Proposal for Supplement 2 to UN Regulation No. 151 (Blind Spot Information Systems (BSIS))

Submitted by the Informal Working Group on Awareness of Vulnerable Road Users proximity in low speed manoeuvres

Insert a new paragraph 6.5.11., to read:

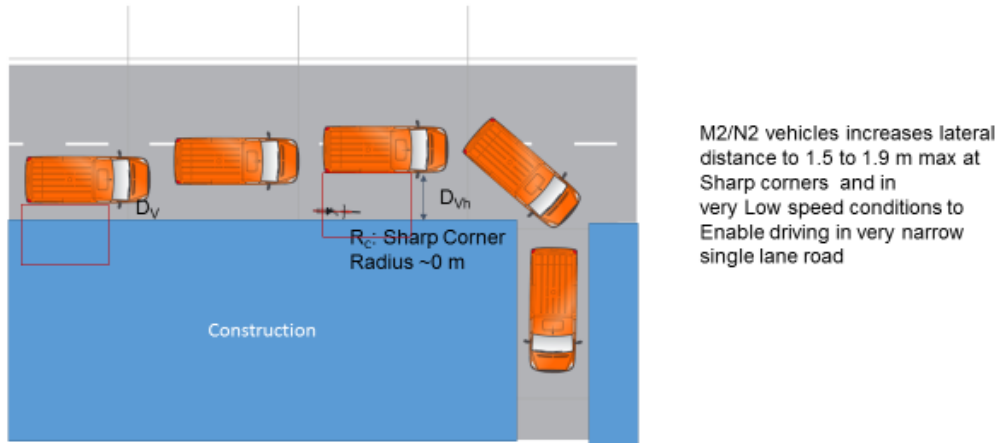
"6.5.11. Vehicles of categories N₂ with a technically permissible maximum mass not exceeding 8 tonnes and M₂ are deemed to meet the requirements of paragraph 6.5. if the Blind Spot Information signal has been activated when the bicycle target is moved forward, rearward or transverse moving forward as specified in paragraph 5.3.1.4.1. and entering a zone on the nearside of the moving vehicle into a zone adjacent to the moving or stationary vehicle. In such case, the specification of the relevant zone and the activation of the information signal shall be in accordance with the manufacturer's specifications. These specifications shall however cover both the entry from the front and from the rear of the manufacturer defined zone."
